ATTACHMENT 2

AIRPORT TRANSIT LINE LETTERS OF SUPPORT

Subject: City of Calgary's Airport Transit Study (ATS)

Subject: Airport Trail Transit Study – Alignment Over Deerfoot Trail

AIRPORT TRANSIT LINE
ROUTE SELECTION STUDY - PREFERRED OPTION
TRACK 1&2 ALIGNMENT WITH INTERCHANGE

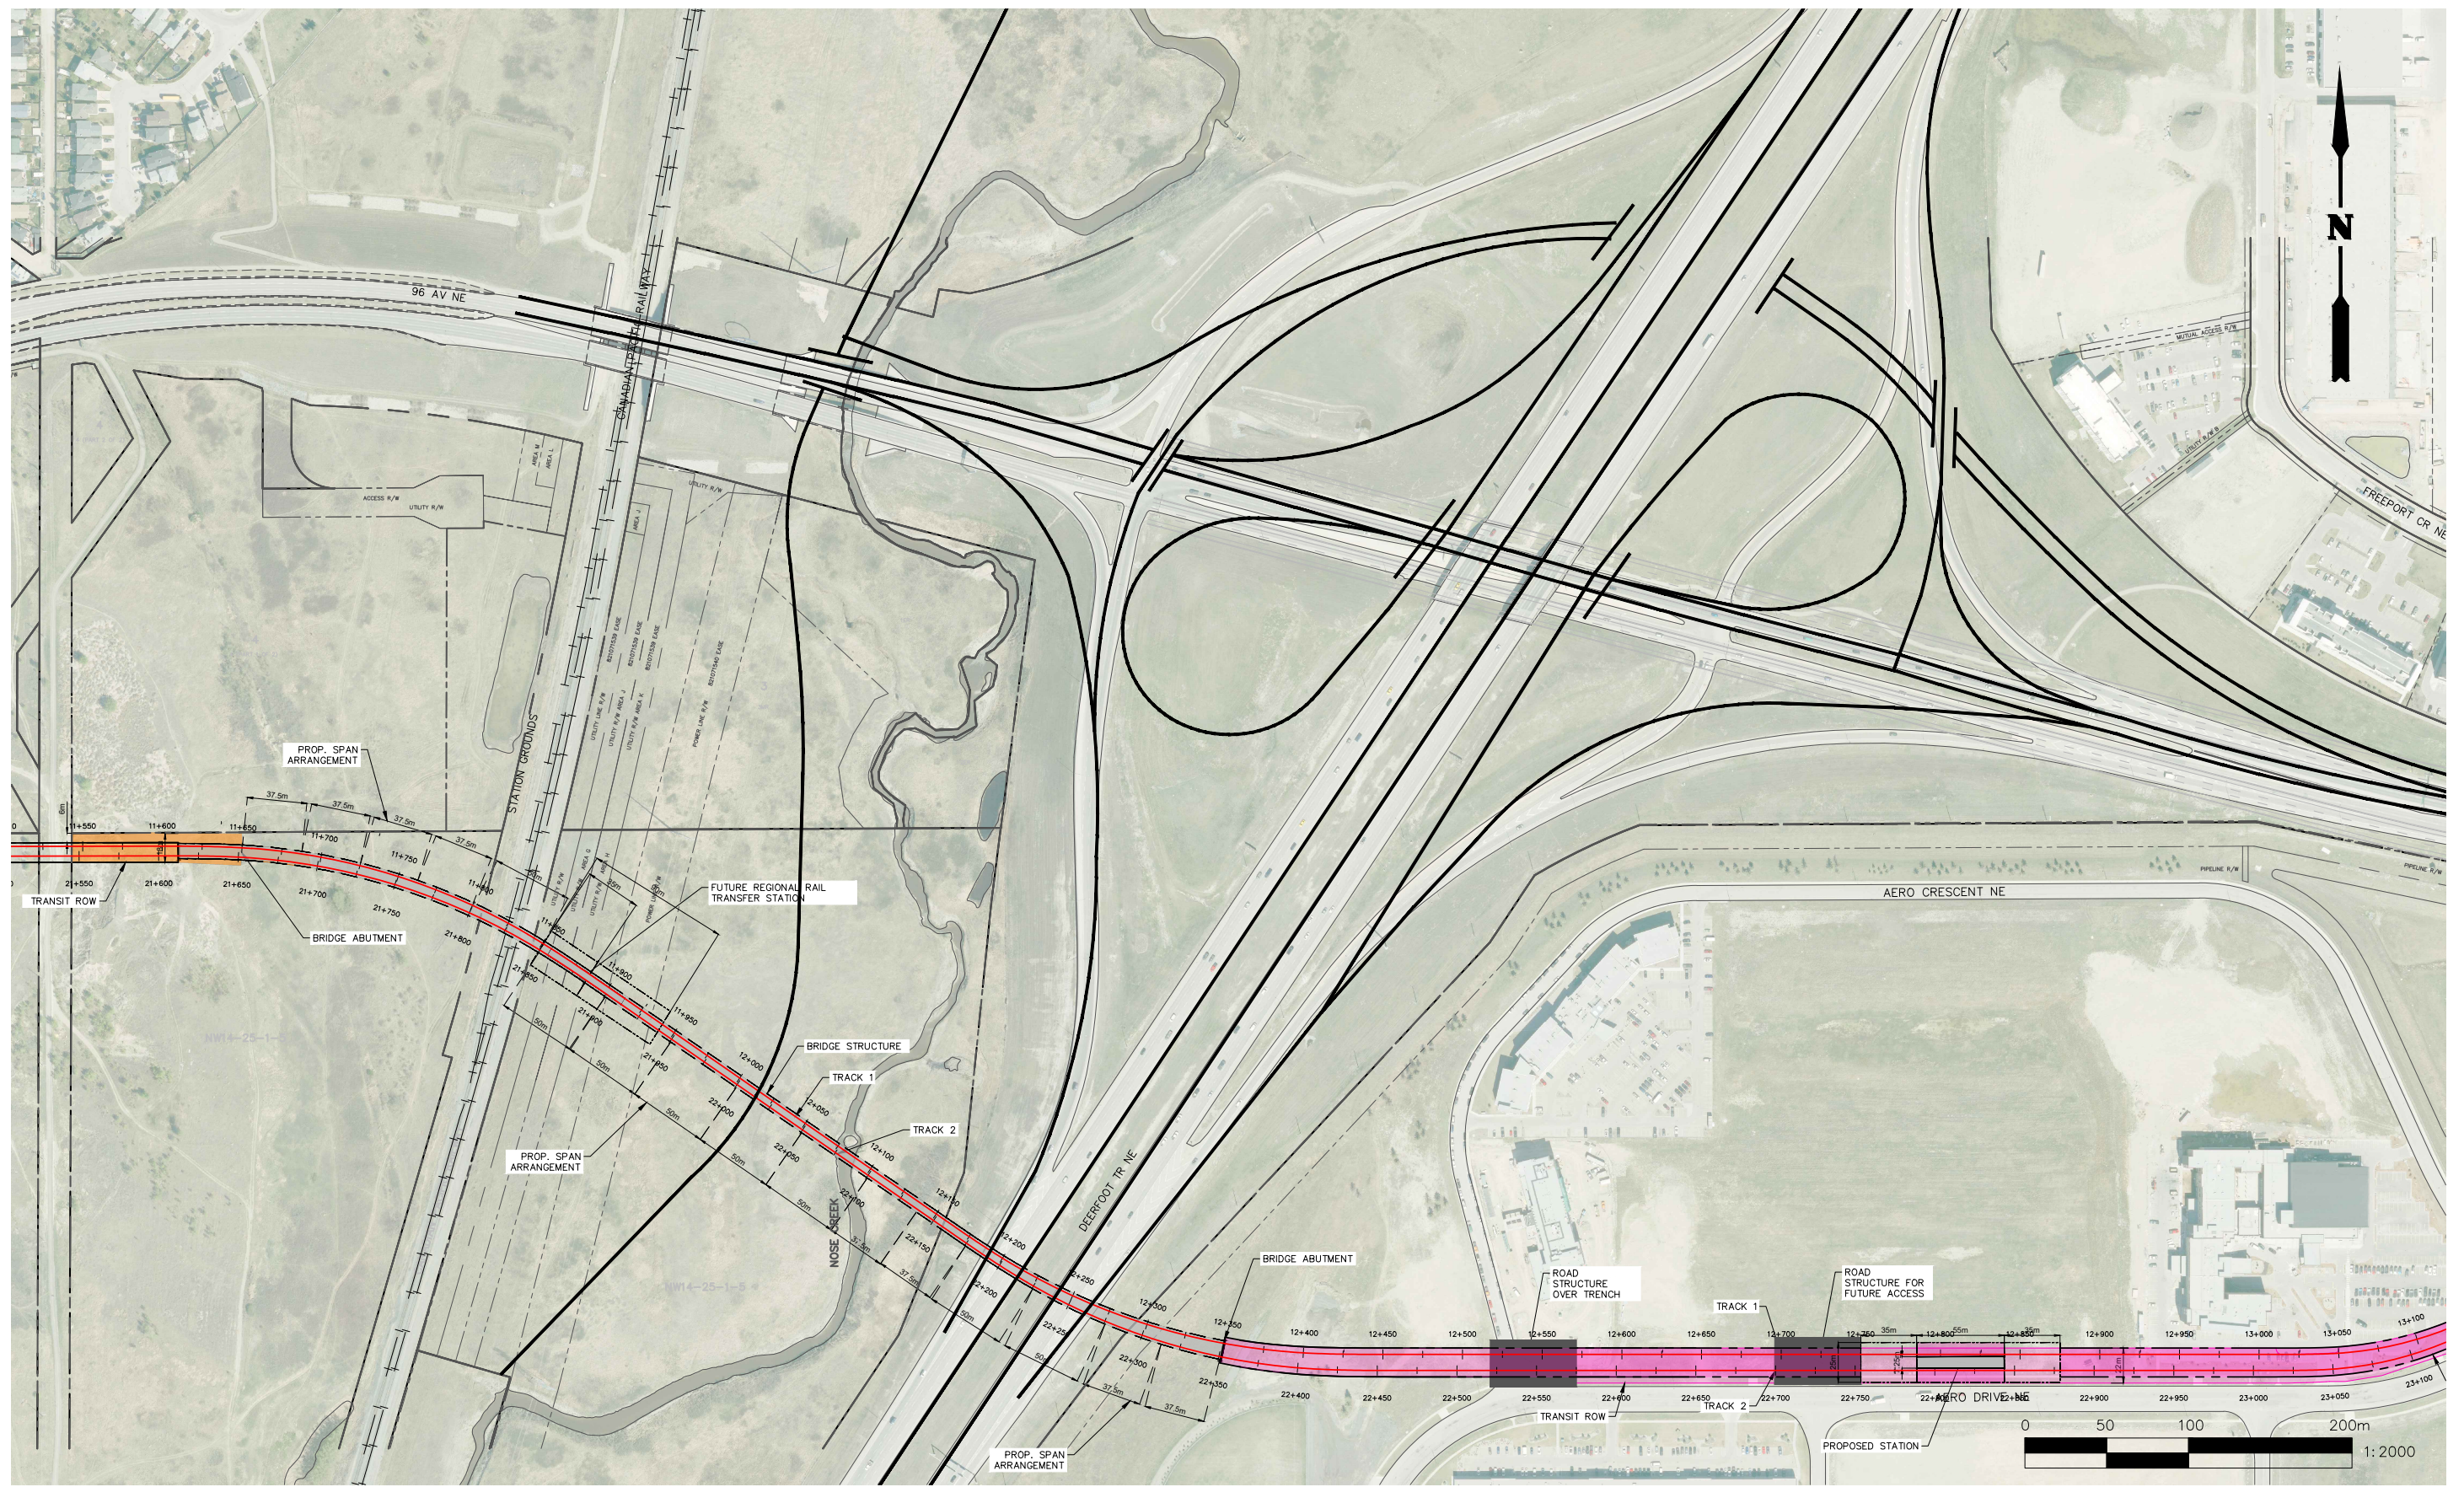
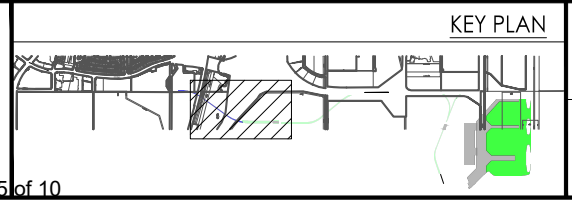
We concur with the recommended alignment as attached, showing the future connection crossing Deerfoot Trail south of the Airport Trail interchange at the existing on/off ramp connections to Deerfoot Trail. This is compatible with the ultimate interchange concept with a westbound to southbound directional ramp at the Airport Trail interchange. Further details would have to be developed, such as vertical clearances and abutment locations to ensure no conflict with future Deerfoot Trail plans.

PROPOSED OVERHEAD STRUCTURE CLEARANCES FOR NEW CONSTRUCTION

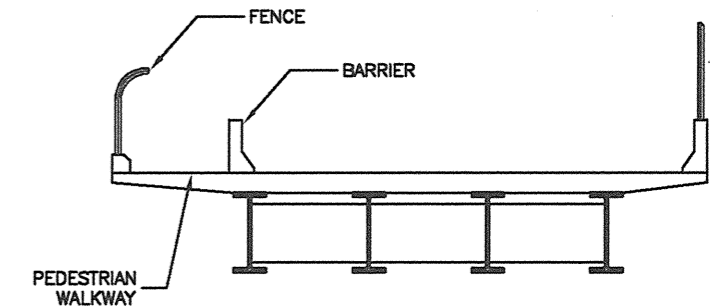
Furthermore, the City should incorporate clearance parameters on the attached PDF (Proposed Overhead Structure Clearances for New Construction) for the proposed above grade separation conceptual design.

Note that for new construction, CP requests that City provide the horizontal clearance to the face of an abutment/pier/wall on the other side of the track from the maintenance/access road of 7.622 m = 25'-0".
